EPC STORMWATER REVIEW COMMENTS
IN ORANGE BOXES WITH BLACK TEXT

GRANDWOOD RANCH

ROAD AND STORM PLANS

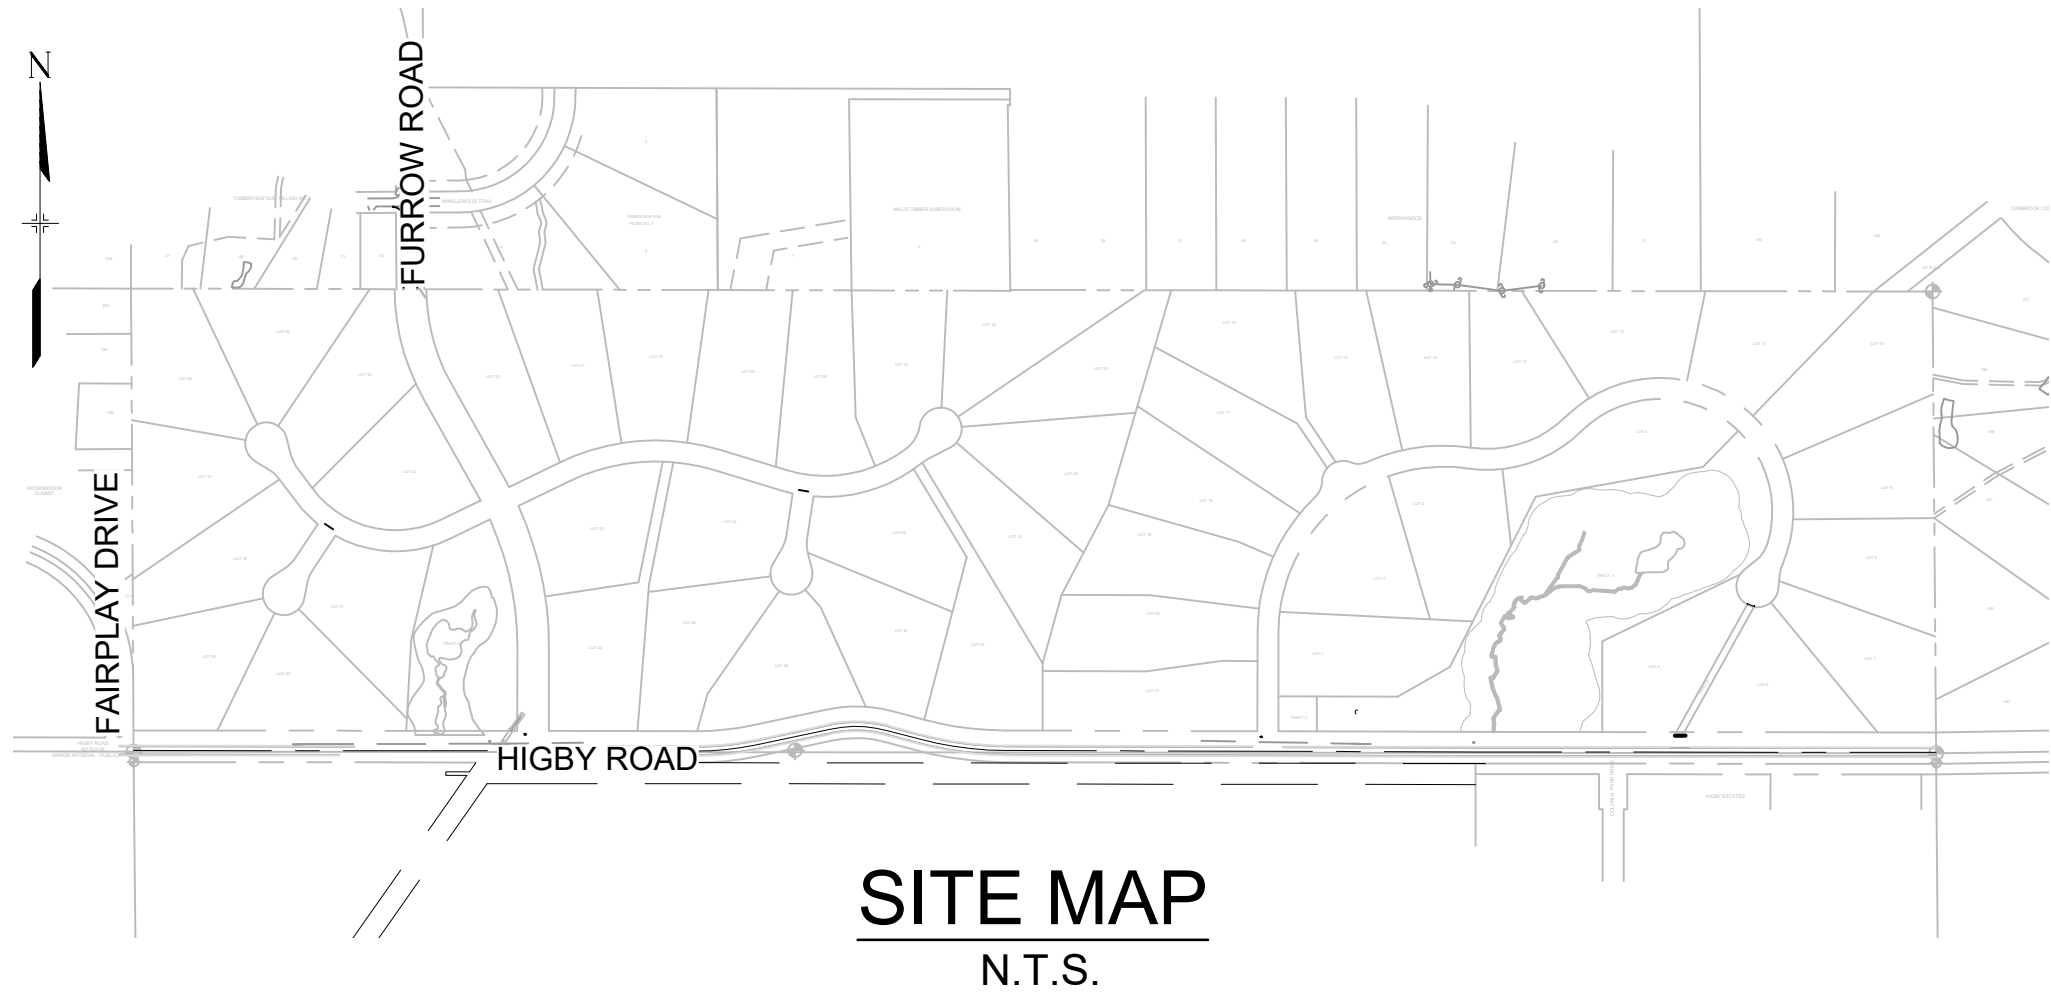
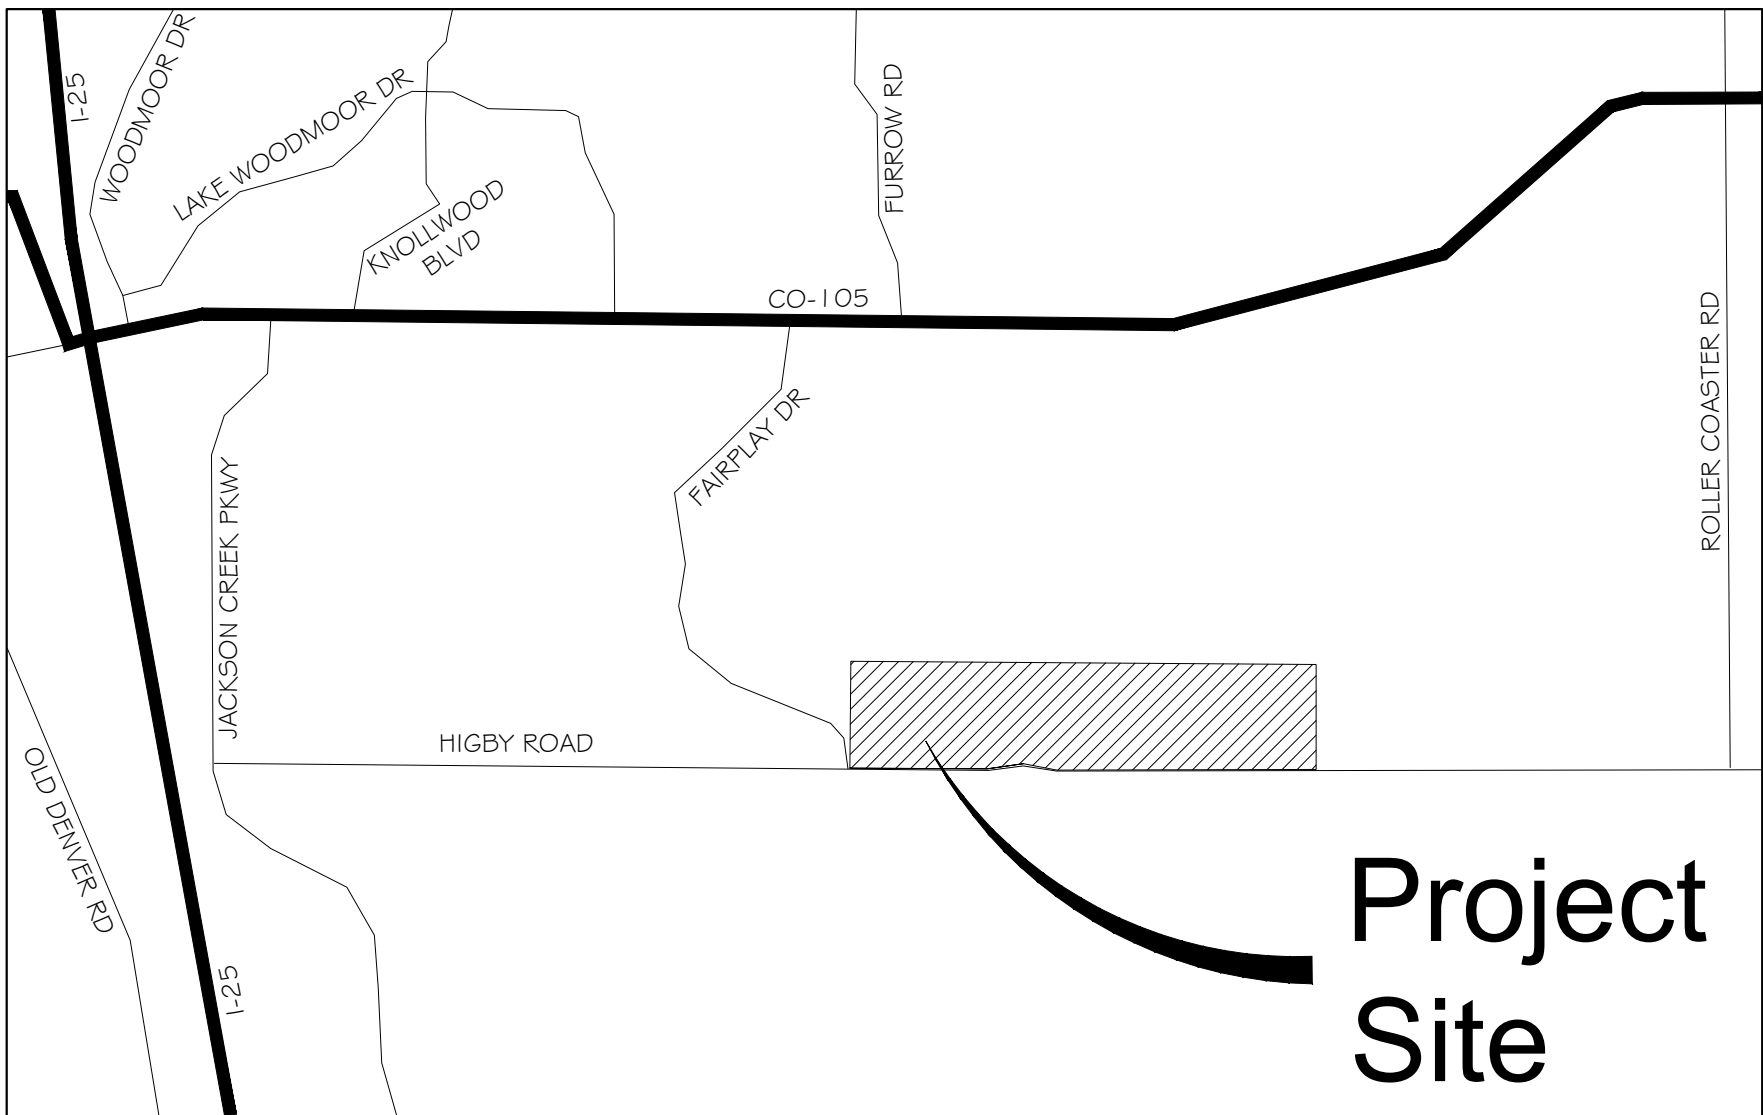
Add governing agencies to title sheet.

Add a signage
striping sheet or call
out on the roadway
plan and profile

Add north arrow to
map.

Add project number PUD #: SF 2026
